Certificate of Appropriateness for 1244 Rutledge

October 28, 2019

Proposed Work

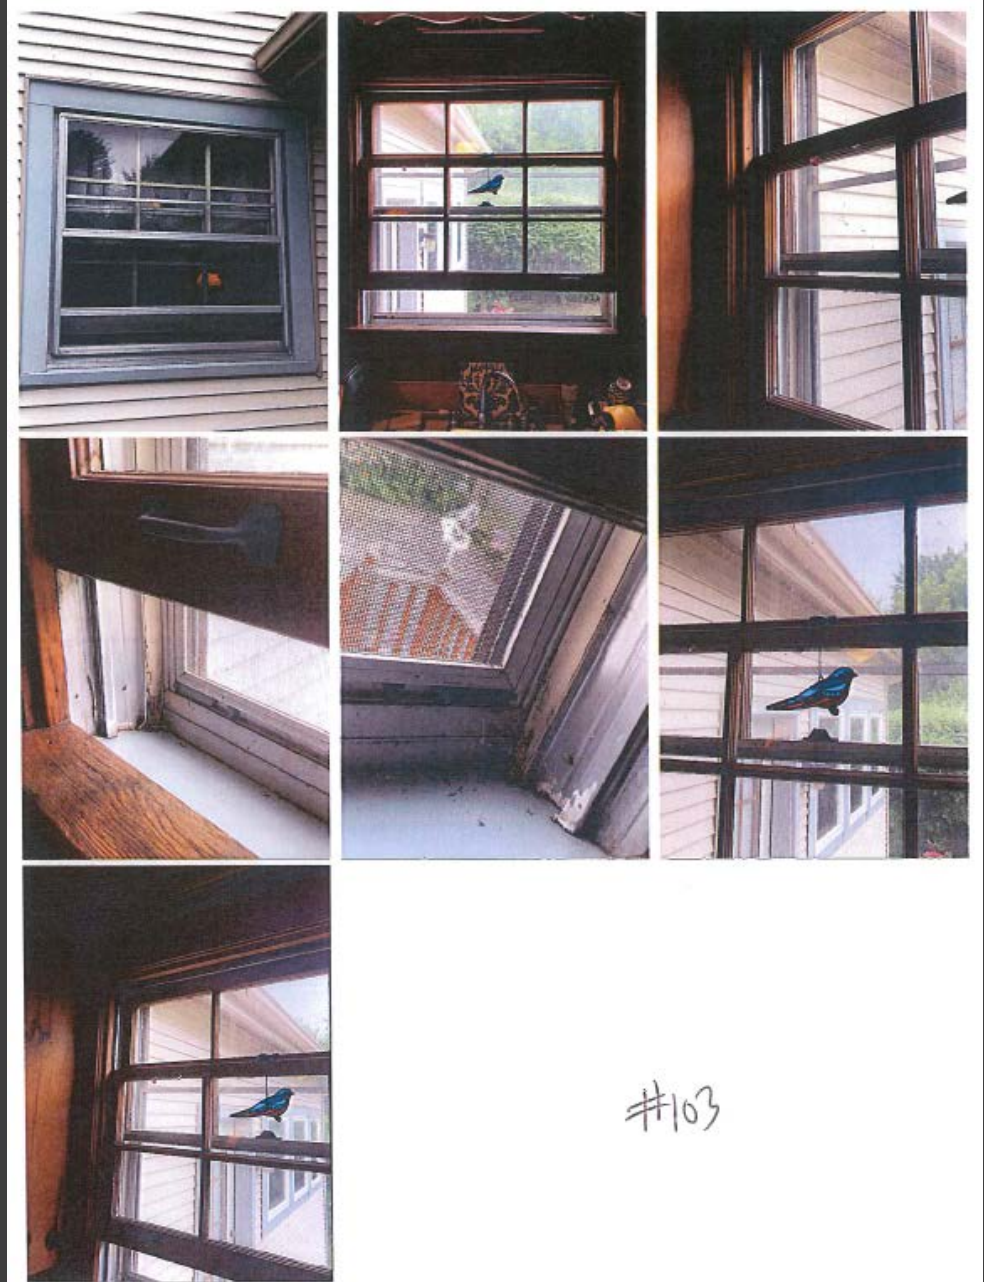
Staff believes that it is unclear if the standards for granting a Certificate of Appropriateness have been met and recommends the Landmarks Commission refer the item to a future meeting and request the applicant supply information on if the existing windows (particularly windows 202, 205, & 206) can be repaired, how the cost of repair compares to the cost of replacement, and information on the measurements of each window, including the window components, and how those measurements compare to the proposed replacements.
